SPC-2023-0357C

Invalid, Incorrect and Incomplete
per Development Codes

“Champions Tract 5”

Prepared by Lakewood Club Neighborhood Organization
PoC: Marcus Shaftel marcus@ieee.org (512) 779-8849

Existing Office
Connections

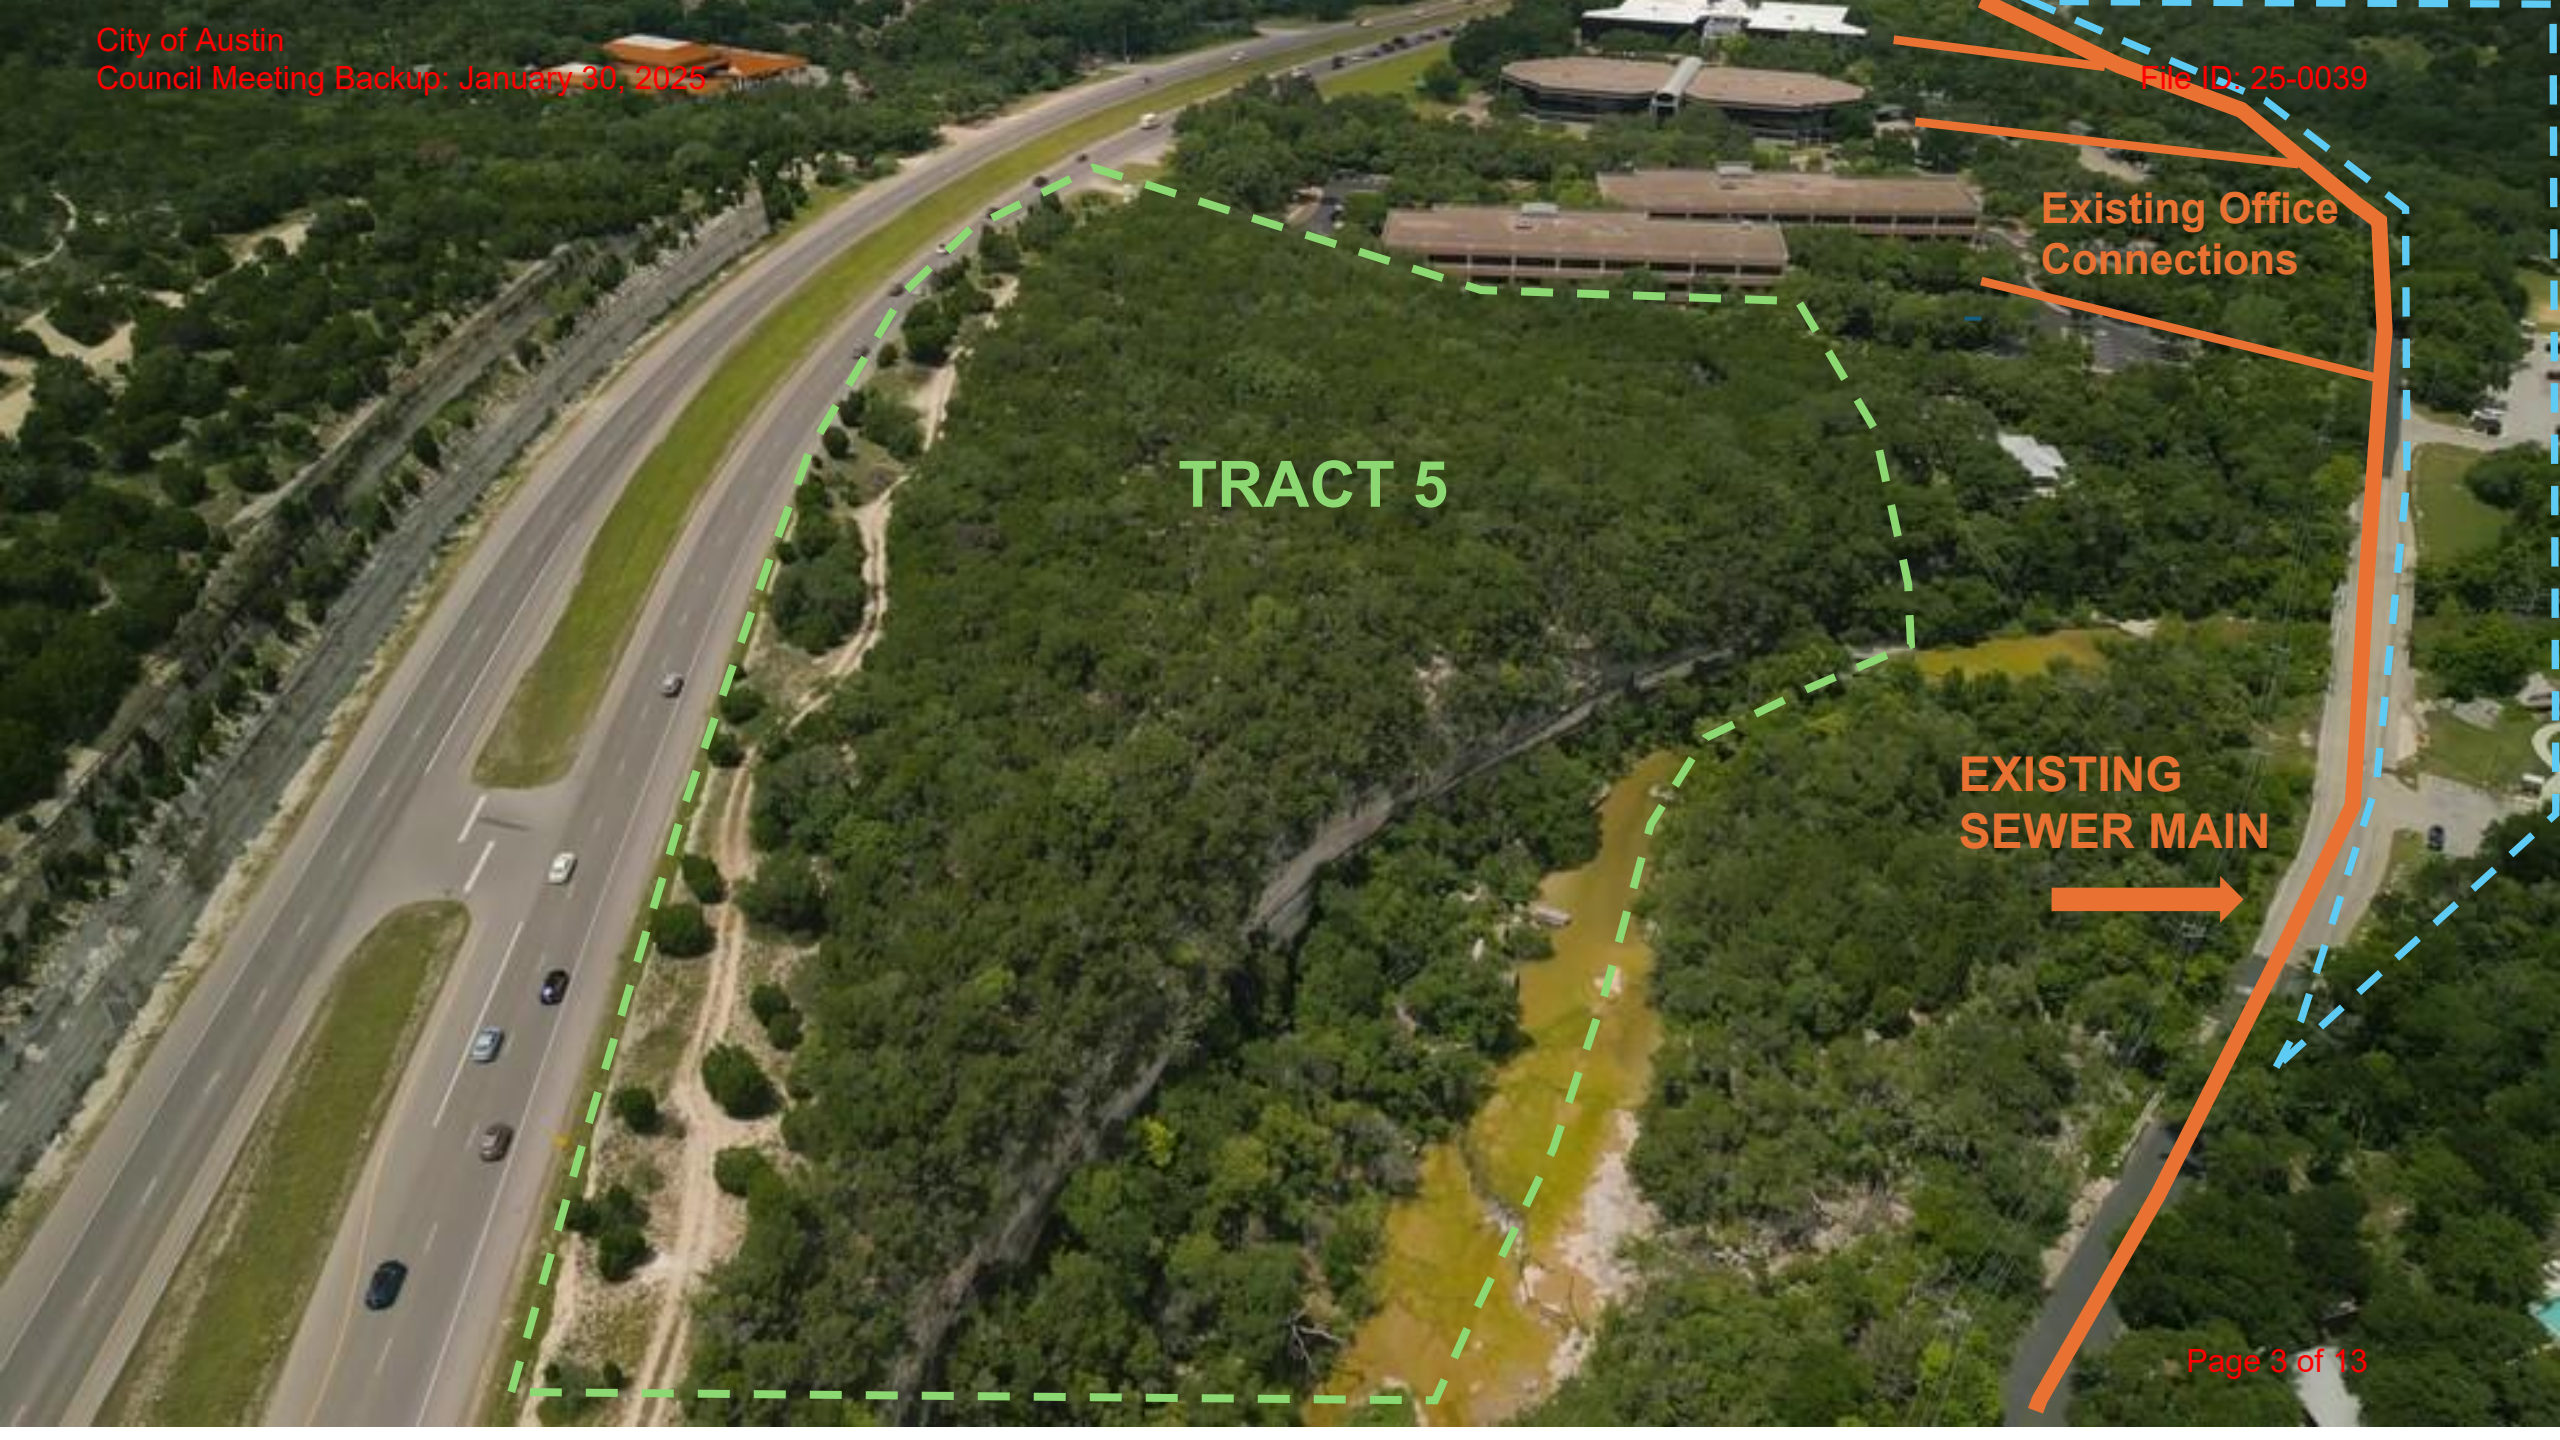
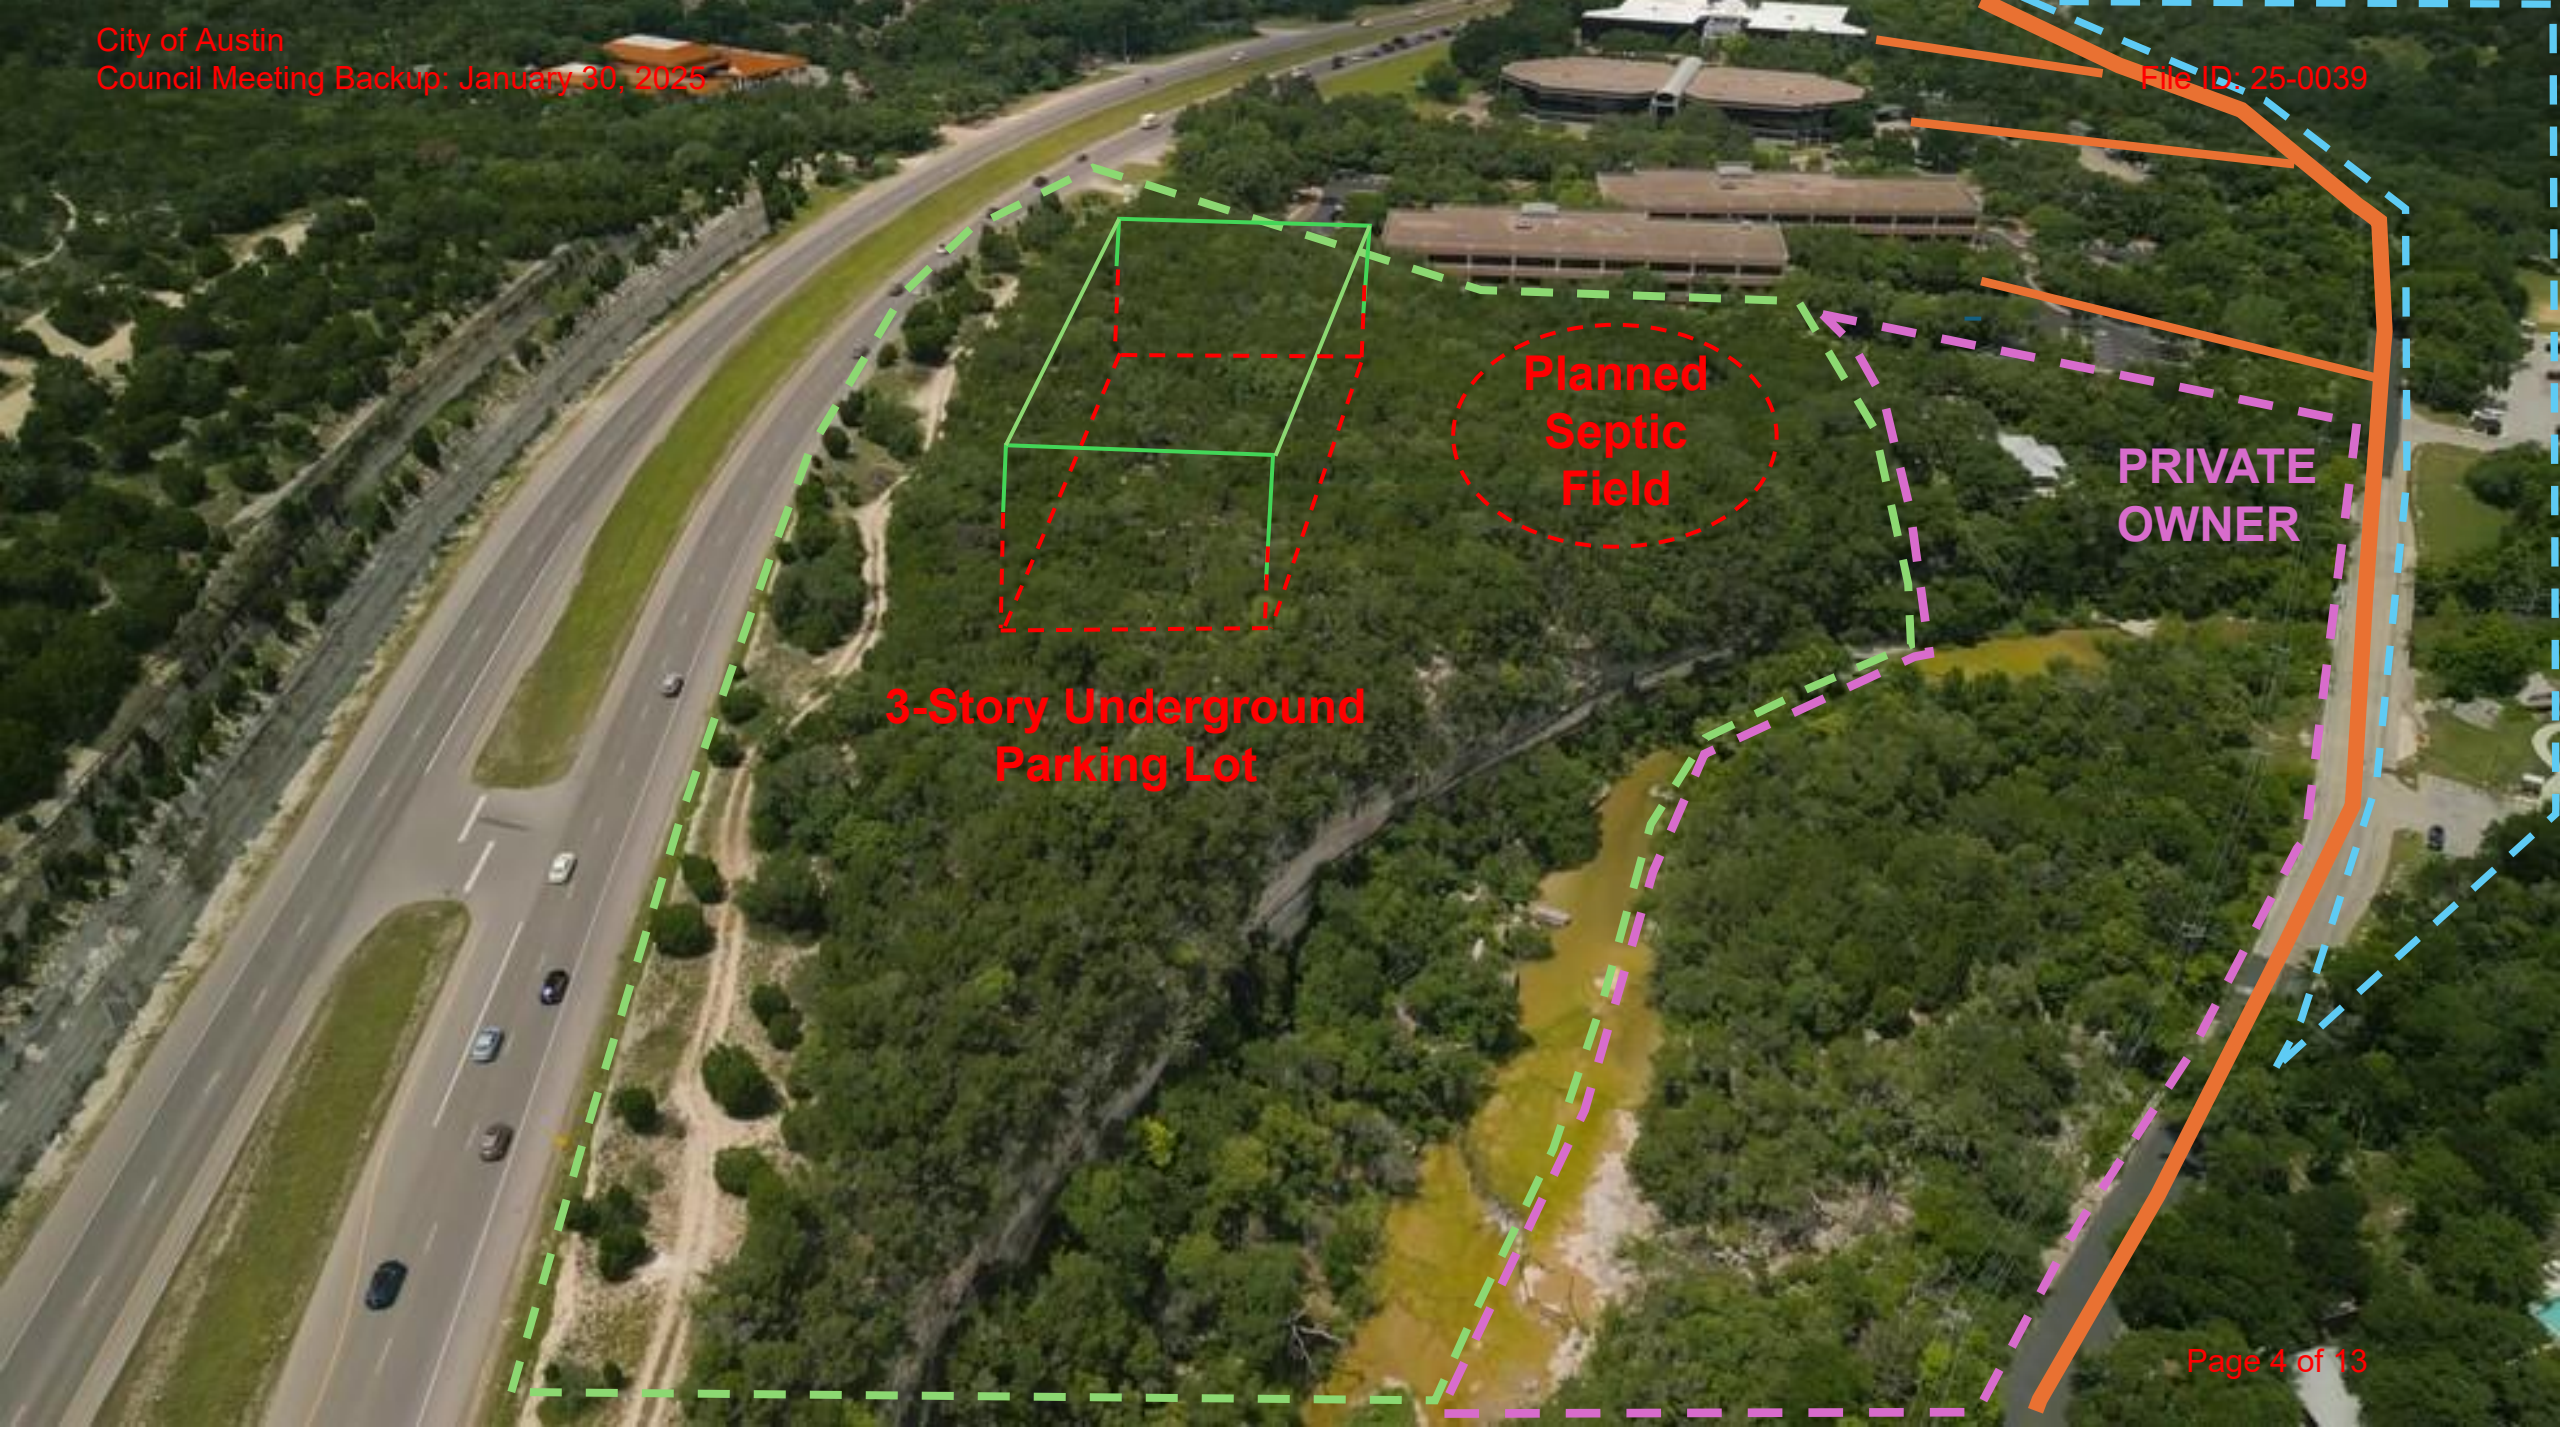
EXISTING
SEWER MAIN

**3-Story Underground
Parking Lot**

**Planned
Septic
Field**

Site Plan Documentation Errors

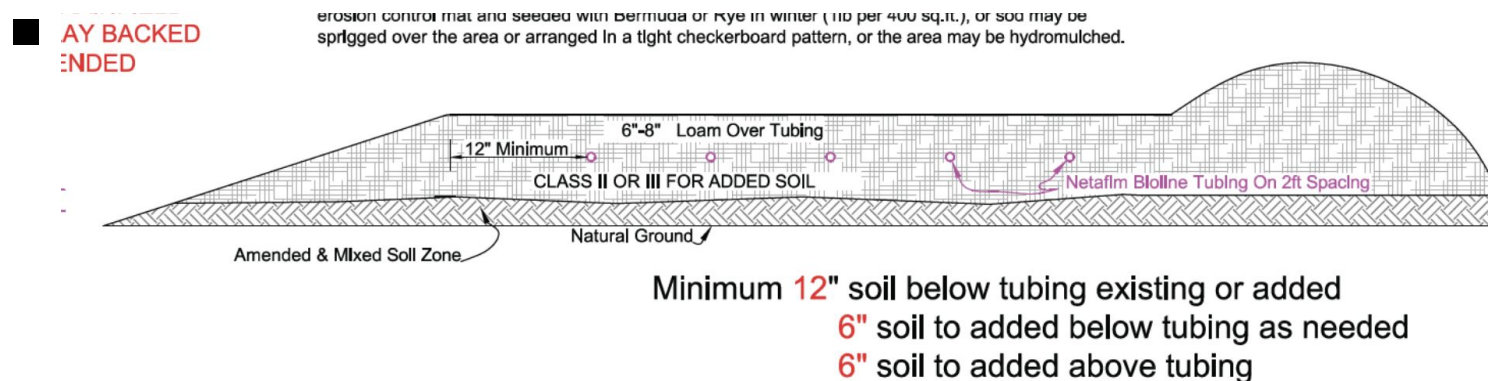
- Environmental Resource Inventory (ERI) is incorrect
 - States **connection to city sewer**
 - Diagrams representing the required soil above and below leach field drip irrigation lines (Page 12) **do not represent the topographic reality of the site**
 - Design assumes “Amended & Mixed Soil Zone” beneath the septic system
 - Core samples show there’s bedrock below it
 - When effluent reaches the bedrock, it will run across the impervious surface and follow the slope, down towards Bull Creek, down the bluff into Bull Creek carrying bacteria and other unfiltered chemicals

- On-Site Septic Facility (OSSF/septic) is incorrect
 - States system is **not adjacent to a waterway**

NOTES:

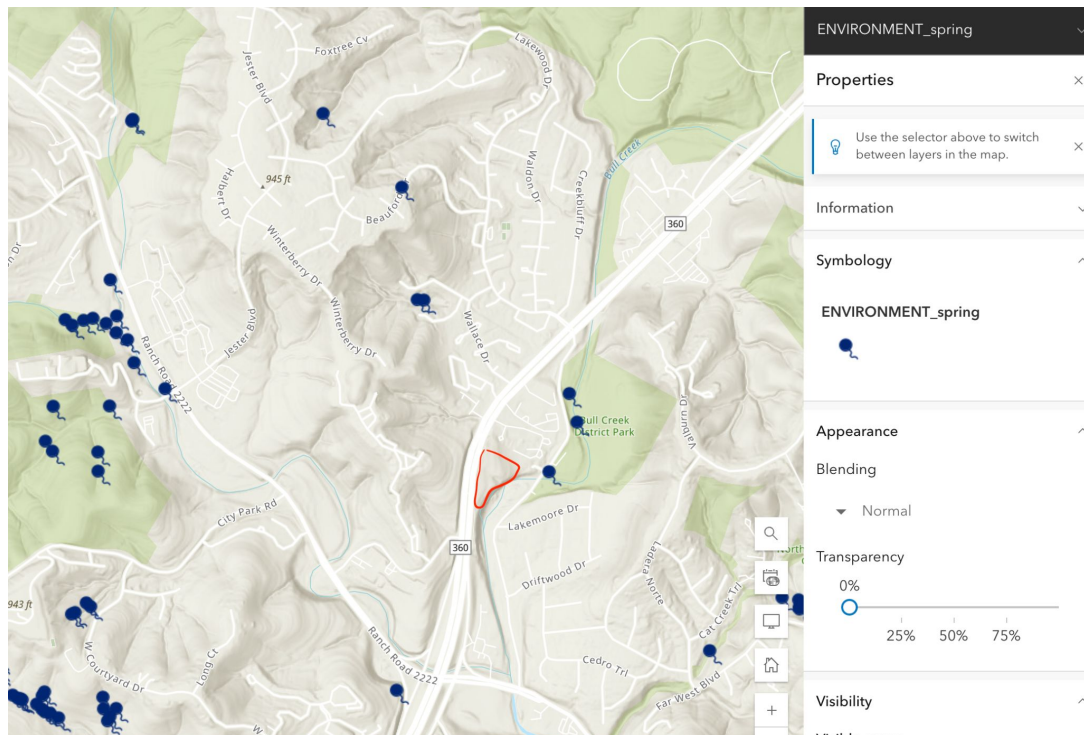
- 2003 Recorded Subdivision Plat Notes Require Connection to City Sewer
 - Therefore the site plan, using septic, is not the continuation of a project under the 2003 Recorded Subdivision, and cannot be approved by ZAP by failure to comply with plat notes
 - Under any version of the code, if the **site plan does not comply with the plat notes it must be denied**
- City Staff did not identify these issues and therefore **material in front of ZAP for consideration is flawed**
